Westwood Heights Window Replacement Solicitation No. 5983

ADDENDUM NO. 1
Issue Date: March 19, 2025

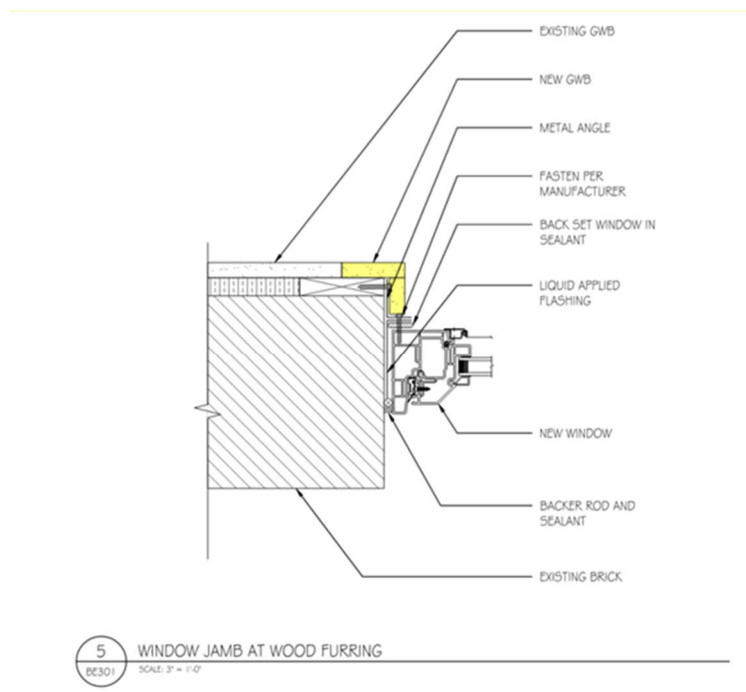
Question 5. Will the standard detail for interior drywall demolition be 6" on each side of the window, for every window on the project?

Response: 6" drywall removal is a reasonable amount needed to remove, refasten new drywall to the furring and blend into the existing drywall. The actual amount might vary by the contractor's means and methods.
